ARKANSAS NUCLEAR ONE - UNIT 1

IMPROVED TECHNICAL SPECIFICATIONS SUBMITTAL

**03/19/01 Supplement
Volume 2 of 2
(Sections 3.9, 4.0, and 5.0)**

March 19, 2001

Figure 4.18.1 5.5.9-1

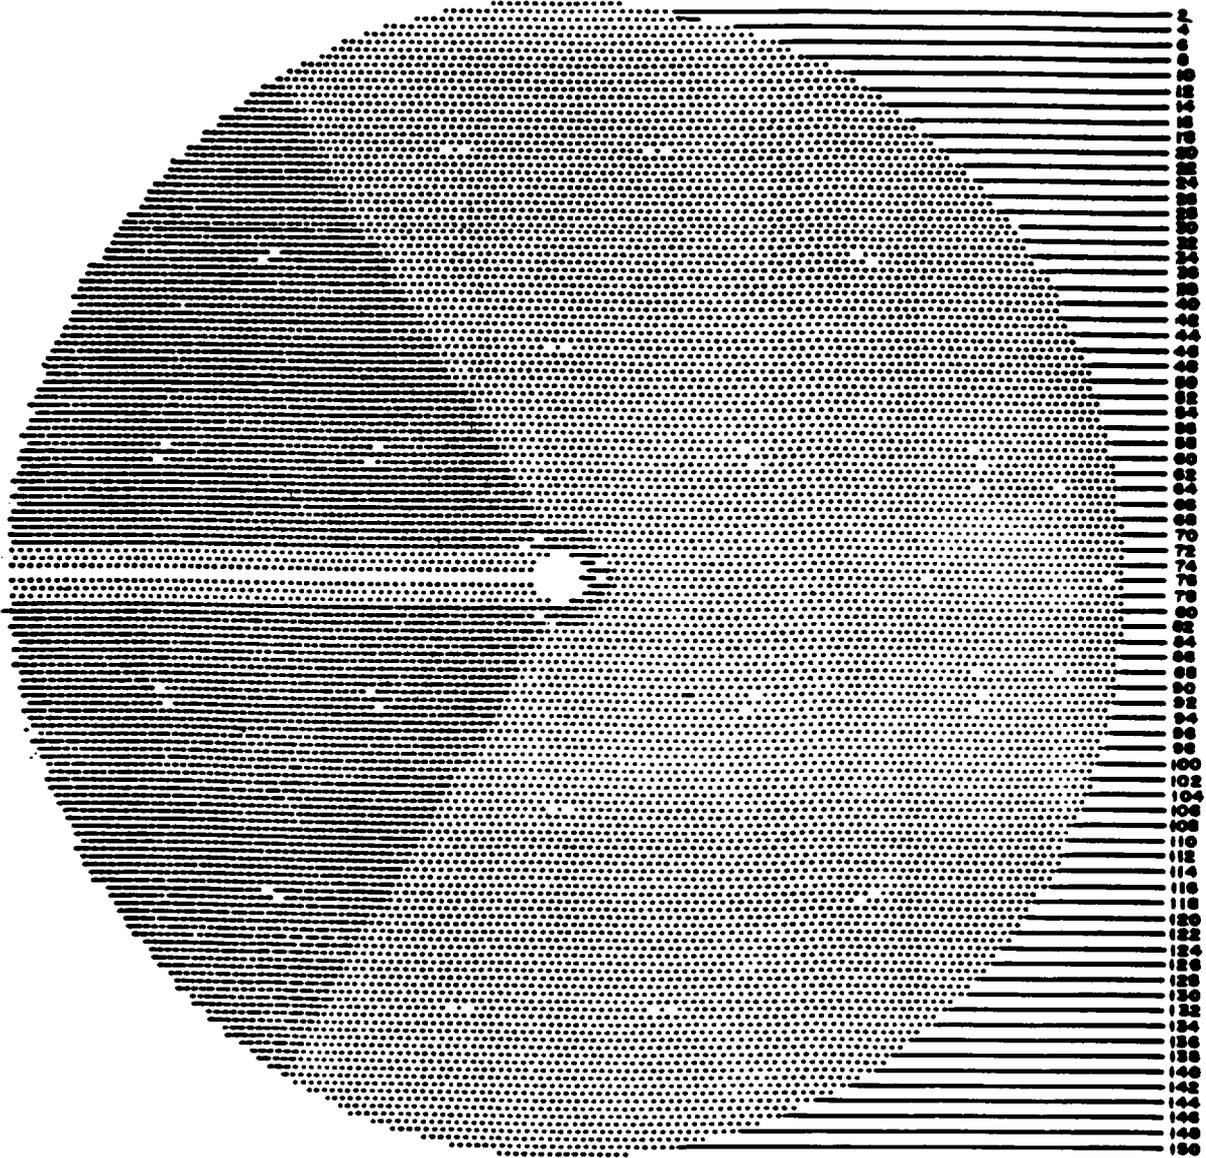
- (1) Group A-1: Tubes within one, two or three rows of the open inspection lane.
- (2) Group A-2: Unplugged tubes with sleeves installed.
- (3) Group A-3: Tubes in the wedge-shaped group on either side of the lane region (Group A-1) as defined by Figure 4.18.1 5.5.9-1 5.5.9.d

Upper Tube Sheet View of Wedge Shaped Group
(Group A-3) per Specification 4.18.3.a.8 5.5.9.c.i.iii

FIGURE 3.2 4-1

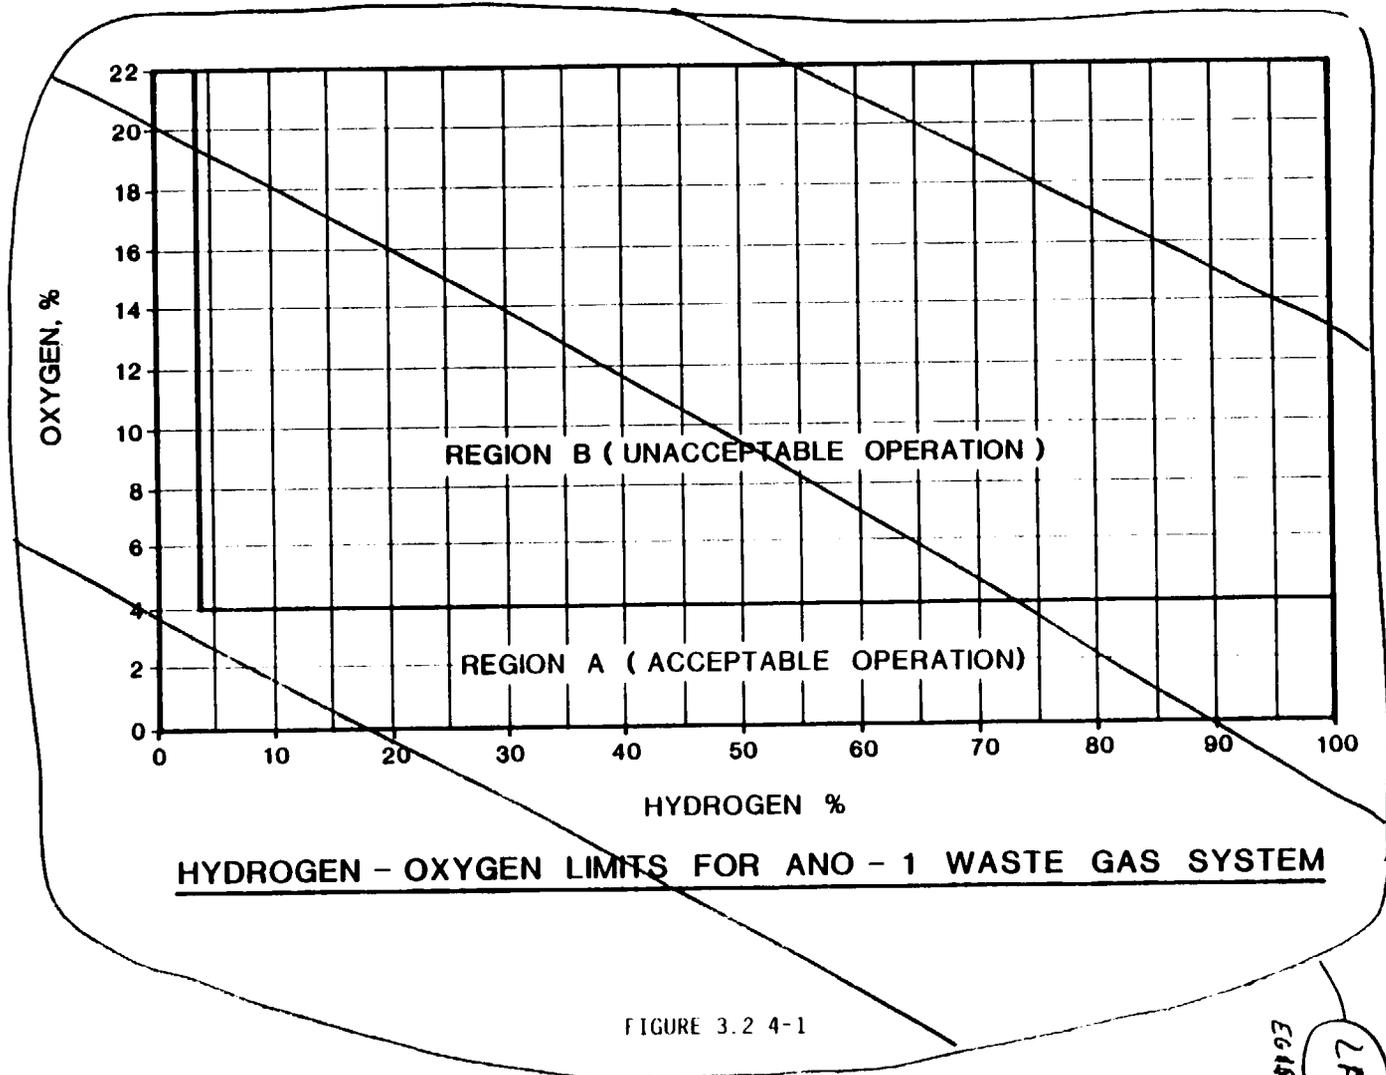
LA5
EGASTAMP

A2
